This gallery shows some pictures of bad solderings - they should prevent you from making the same errors (feel free to add even more pictures here!)

Permanent link:
https://midibox.org/dokuwiki/doku.php?id=bad_solderings_gallery&rev=1160904901

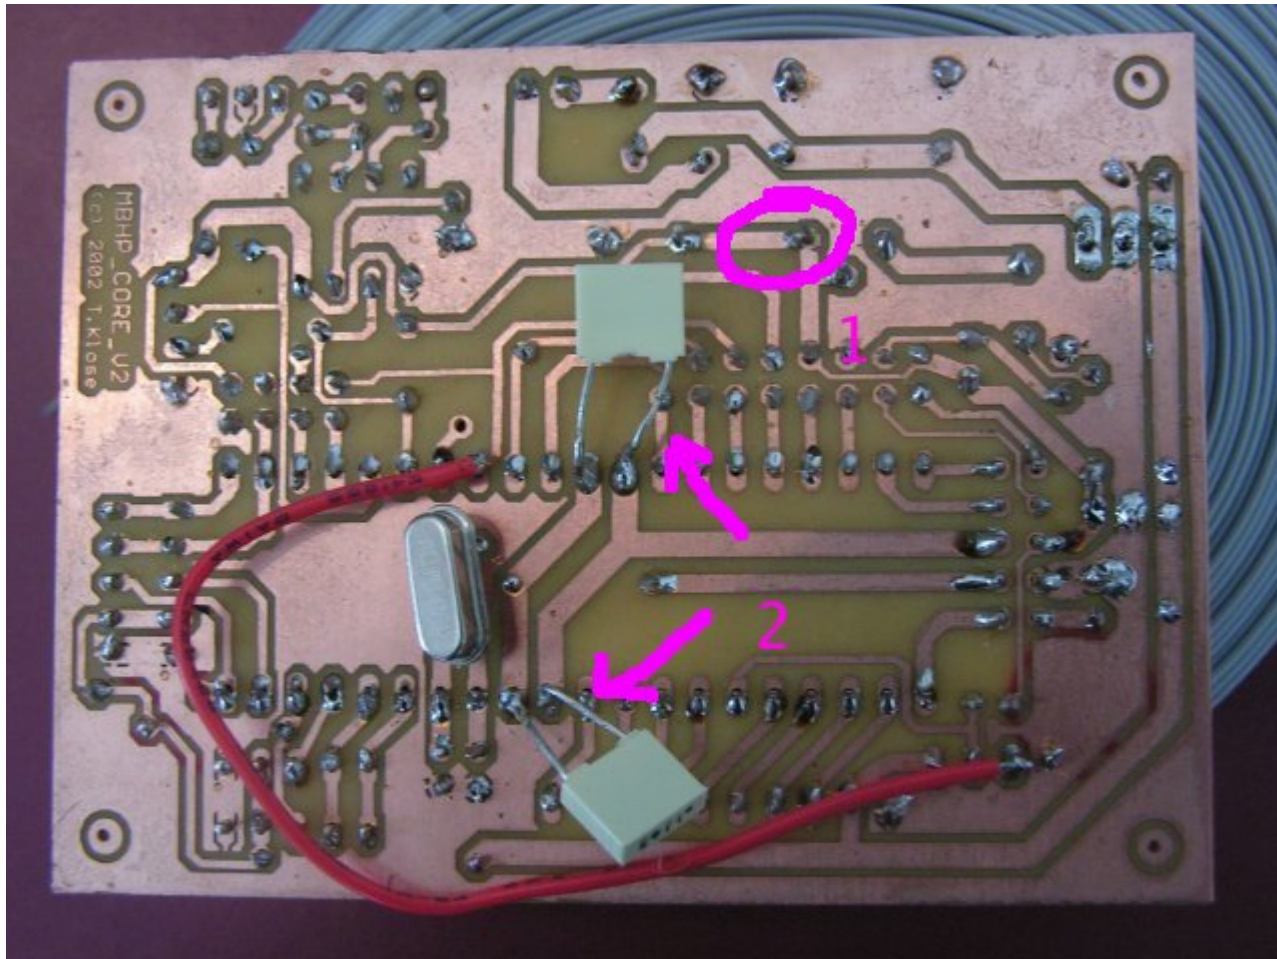
1: the core module has some bad solderings (loose connections), which could lead to failures. There are also missing solderings (e.g. 33pF cap below crystal). It makes sense to solder each pad again, the [Soldering](#) guide in the Wiki gives some useful tips

2: the legs of the caps should be cutted, otherwise they can cause a short circuit which can damage the PIC!

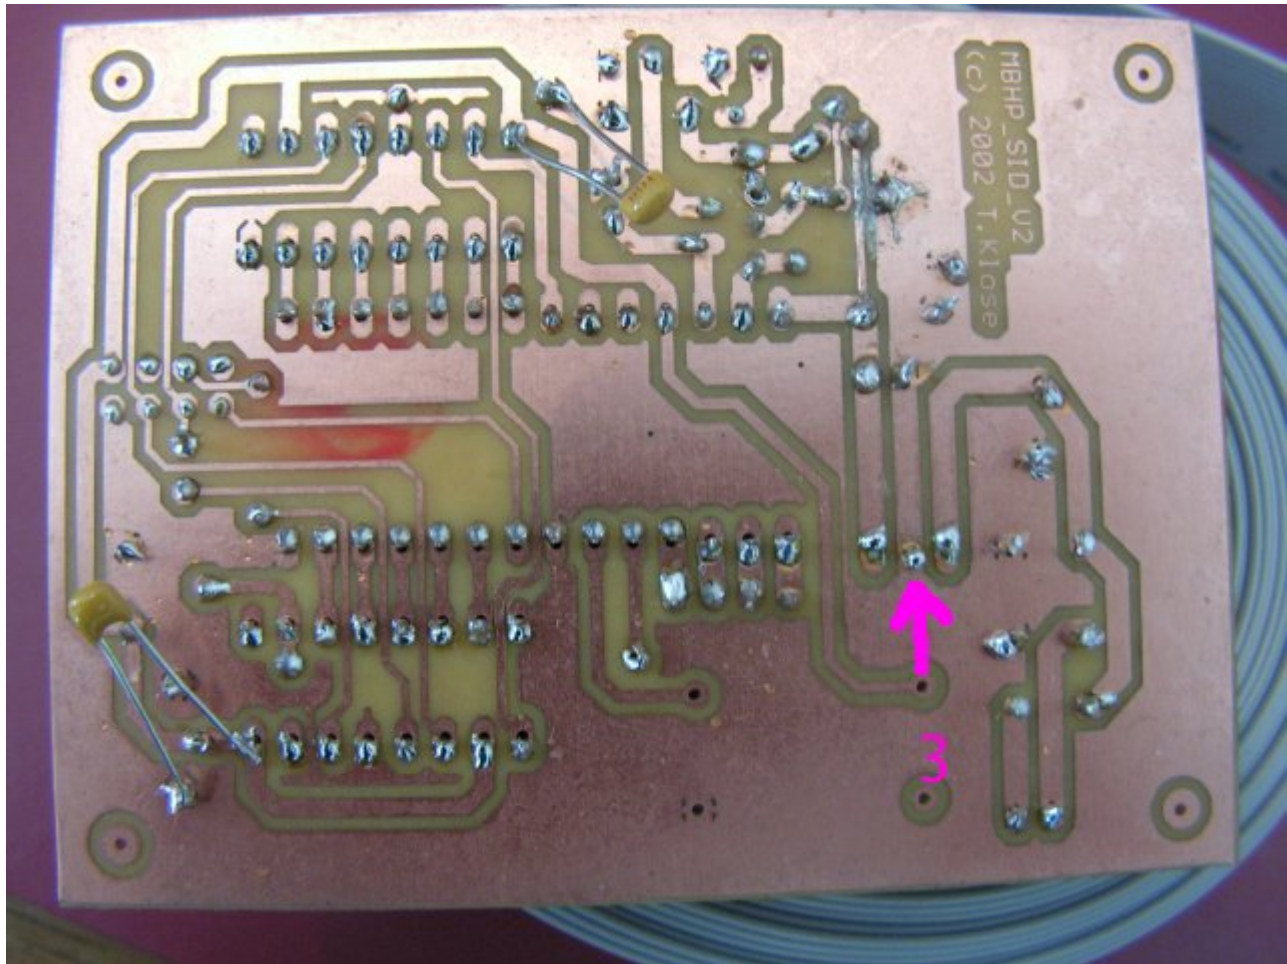
3: this seems to be a bad ground connection directly at the 78xx - it can lead to the wrong voltage. Here the same: just solder the pads again, it will help

And same like above: the long cap legs need to be cutted, the danger for shorts is too high!
